Well Name: COTTON DRAW UNIT	Well Location: T25S / R32E / SEC 21 / SENW / 32.1177713 / -103.6822506	County or Parish/State: LEA / NM
Well Number: 30	Type of Well: INJECTION - ENHANCED RECOVERY	Allottee or Tribe Name:
Lease Number: NMLC061869	Unit or CA Name: COTTON DRAW DELAWARE	Unit or CA Number: NMNM70928A
US Well Number: 3002508208	Operator: CHEVRON USA INCORPORATED

Subsequent Report

Type of Action: Plug and Abandonment

**As Plugged  
WELLBORE DIAGRAM**

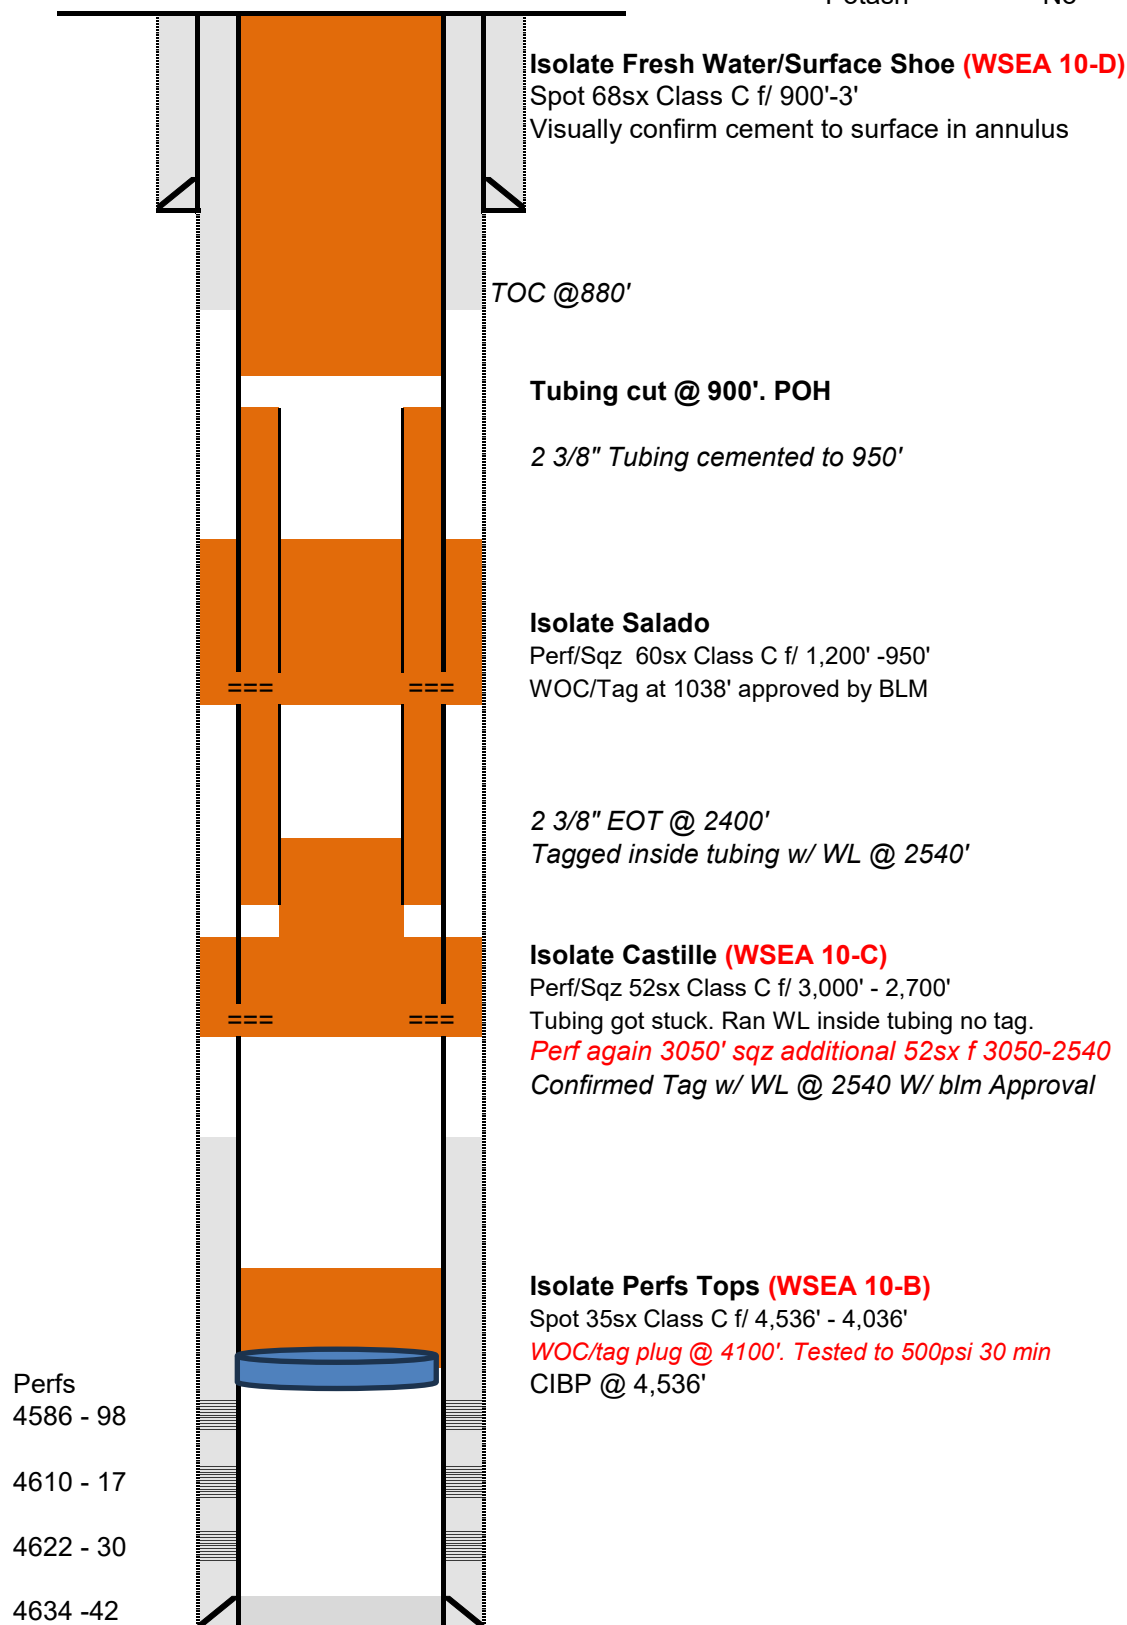
Thanks for taking my call. We have confirmed that we are free from surface to 950'. Please see the proposed plan with your approval.

1. We will attempt to perforate and sqz through tubing out the casing from 1200'-950' to cover the Salado. We will pump 60sx WOC. Tag inside tubing with wireline.
2. Once we tag with wireline +/- 950' cut the tubing @ +/- 900'. Confirm we are free.
3. The CBL shows we have cement from surface to 880' behind the 4 1/2" casing. We then will top of well from 900' to surface inside the 4 1/2" casing w/ 60sx class c

Hi Julio,  
As we discussed with your approval sir, we spotted our castille plug from 3000-2700 with 52sx.  
We are now stuck, we ran WL inside tubing and tagged @ 2540'.

We would like to cut tubing @ 1500 and continue to plug from there. Our next plug is f/ 1200-625.

Hi Julio,  
Just emailing you from our conversation from yesterday with us tagging at 4,100' instead of

4,036' per the proposed WBD.

Please see attached CBL data for the CDU 30 we ran on Friday. Please review the slight changes to the program going forward with your approval.

Plug # 1 – No changes

Plug # 2 – No changes – we will still shoot and attempt to squeeze this plug. However, CBL shows cement on psi pass run that may restrict us from squeezing. If we psi up to 1000psi with

no injectivity, requesting to spot 50' below shots and make this inside plug only f/ 3050-2600 w/ 30sx class C

Plug # 3 – No changes

Plug # 4 – CBL confirms cement behind casing from ~850' to surface. We will not cut/pull casing, plan is to make this inside plug f/ 425' to surface w/ 30sx class C

The BLM grants you verbal approve to proceed with the plan as proposed.

The BLM grants you verbal approve to proceed with the plan as proposed.

The BLM grants you verbal approve with one change please go from 475'- surface on last plug not 425'.
